STATE OF MAINE
 DEPARTMENT OF TRANSPORTATION
 16 STATE HOUSE STATION
 AUGUSTA, MAINE 04333-0016

December 15, 2020
 Subject: Highway Safety Improvements
 State WIN: 018637.00
 Location: **Westbrook**
Amendment No. 1

Please make the following changes to the Bid Documents:

SIGNALIZATION OF
CUMBERLAND MILLS ROTARY
TRAFFIC SIGNAL PLAN
(2 OF 10)

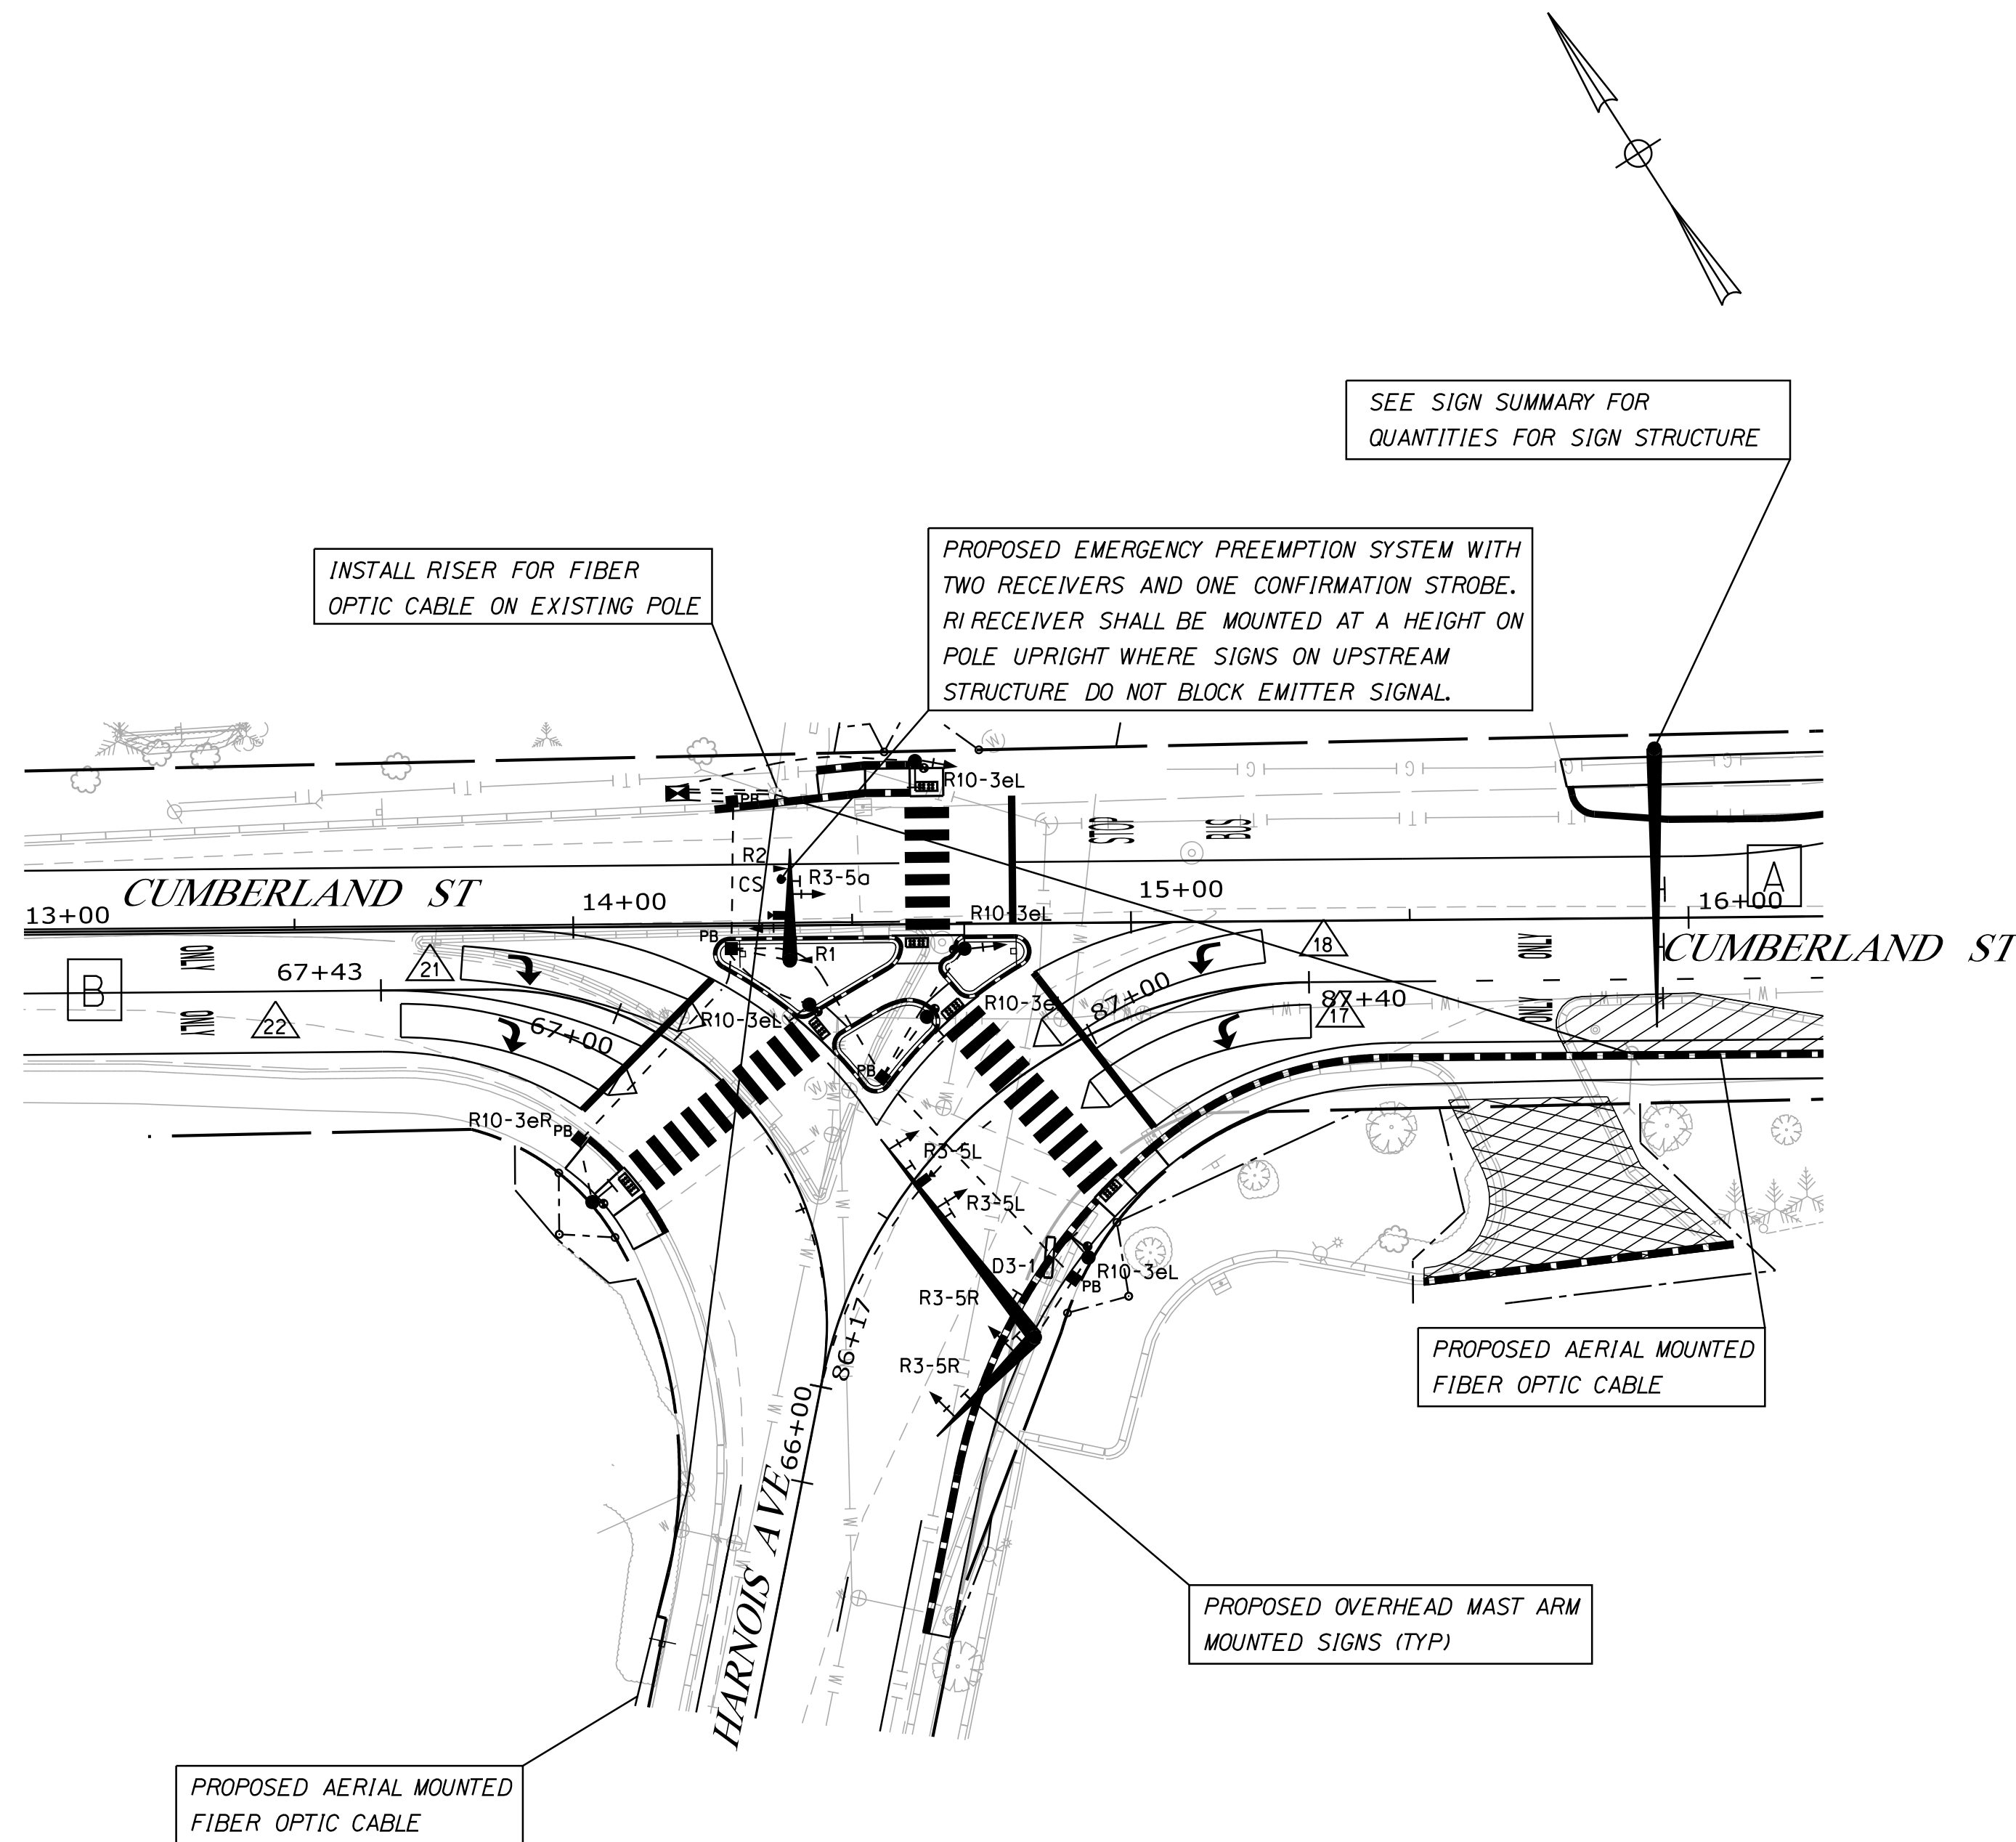
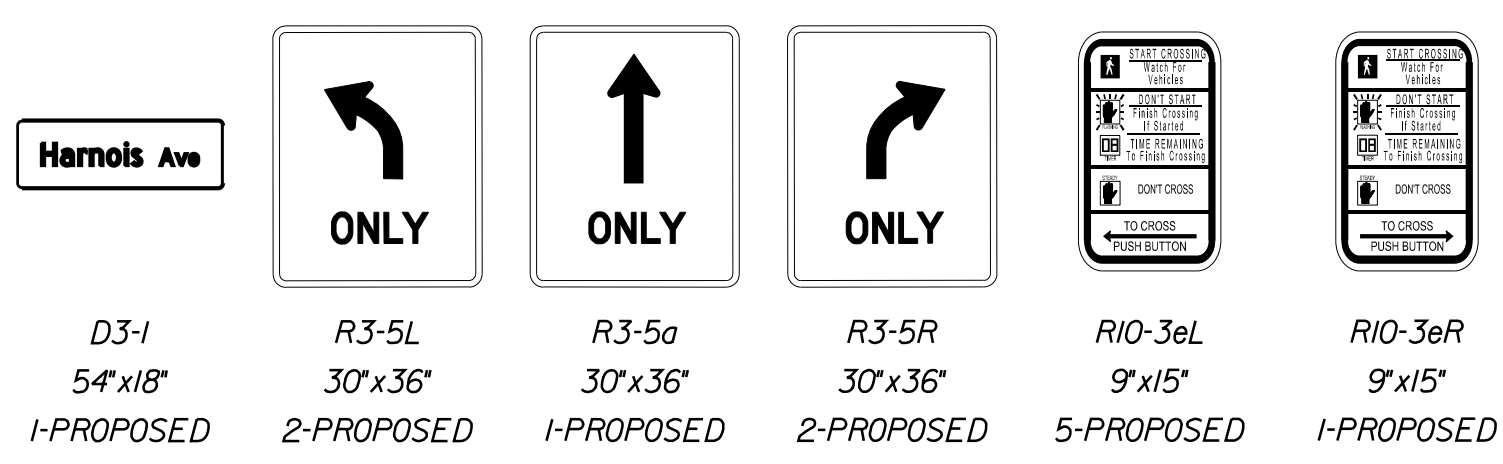
Question: Plan sheet 20 shows a spread footing, item 626.501 for the 35' x 25' dual mast arm, but sheet 39 lists a 48", 54" or 60" diameter foundation item 626.333, which is correct?

Response: See above changes to Plan Set.
